Product / Process Change Notification (PCN)

PCN Number: PCN_rfMCA_20241028

Affected Series: WE-MCA

Because of a database mismatch, Würth Elektronik eiSos will correct datasheet information regarding packaging drawing and dimensions.

Change 1: package drawing change

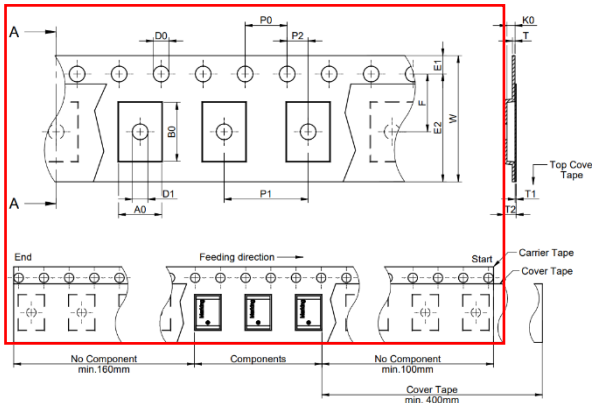
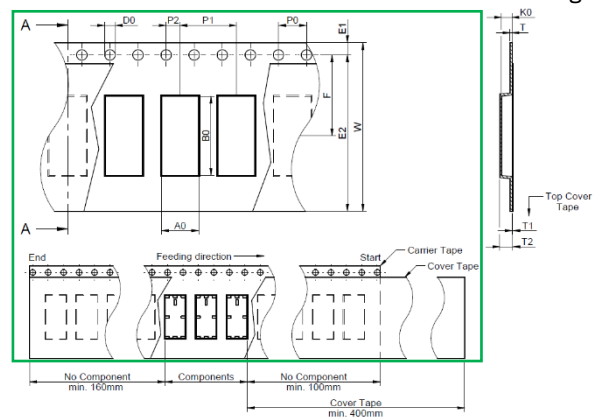
The original drawing had a wrong reel representation.

The correction consist on the modification of drawing.

Change 2: Package dimensions correction

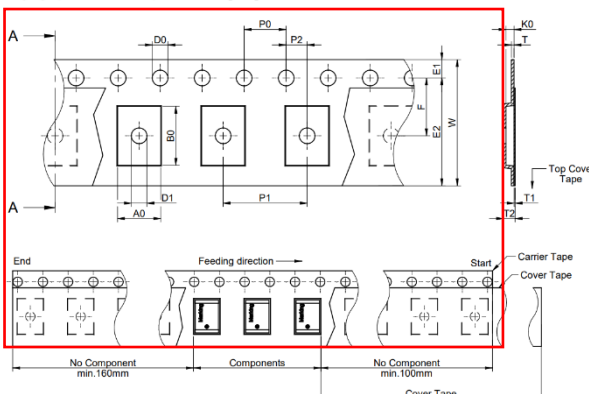
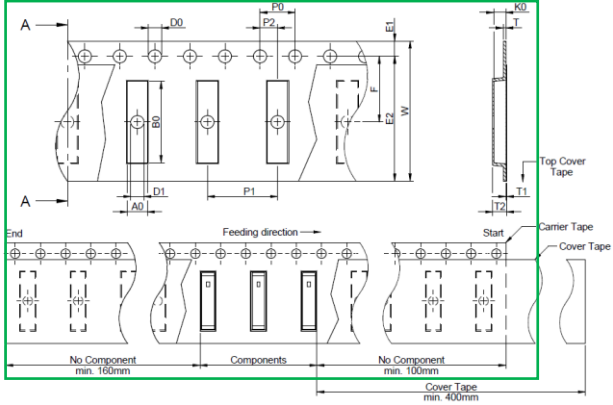
Before Change	After Change
A0:	4.1 mm	5.3 mm
B0:	5.6 mm	11.3 mm
W:	12 mm	24 mm
T2:	1.4 mm	1.85 mm
K0:	1.02 mm	1.75 mm
E2:	10.25 mm	22.25 mm
F:	5.5 mm	11.5 mm
Qty:	2000 pcs	1000 pcs
B:	1.5 mm	2.3 mm
C:	12.8 mm	13.5 mm
W1:	12.4 mm	24.4 mm
W2:	18.4 mm	25.5 mm
W3 min:	11.9 mm	23 mm
W3 max:	15.4 mm	24.3 mm

Change 1: package drawing change

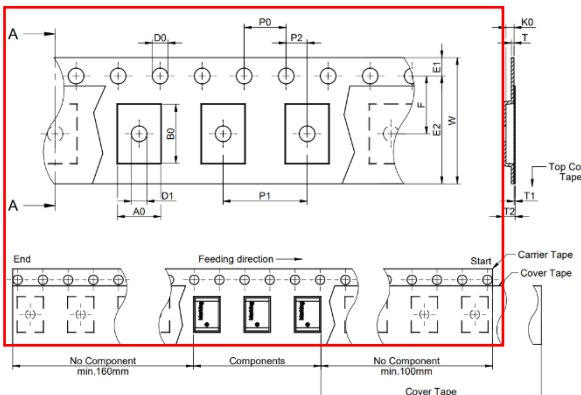
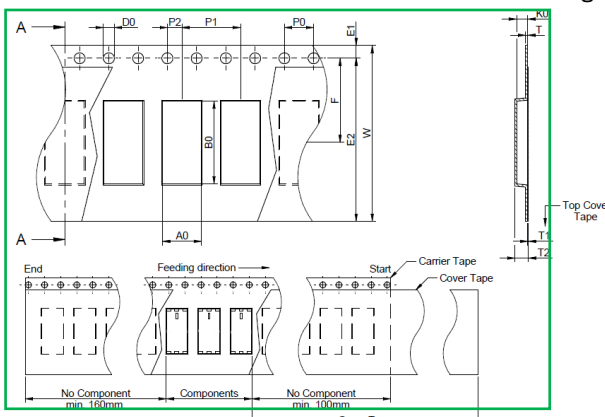
Before Change	After Change
<p>The original drawing had a wrong reel representation.</p> <p>Packaging Specification - Tape and Reel: [mm]</p> 	<p>The correction consist on the modification of drawing.</p>

Change 1: package drawing change

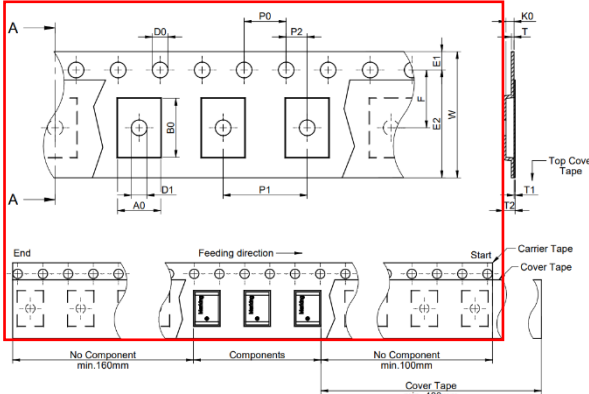
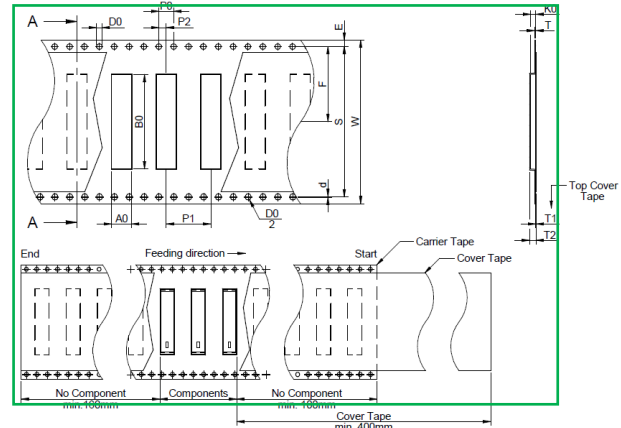
Before Change	After Change
<p>The original drawing had a wrong reel representation.</p> <p>Packaging Specification - Tape and Reel: [mm]</p> 	<p>The correction consist on the modification of drawing.</p>
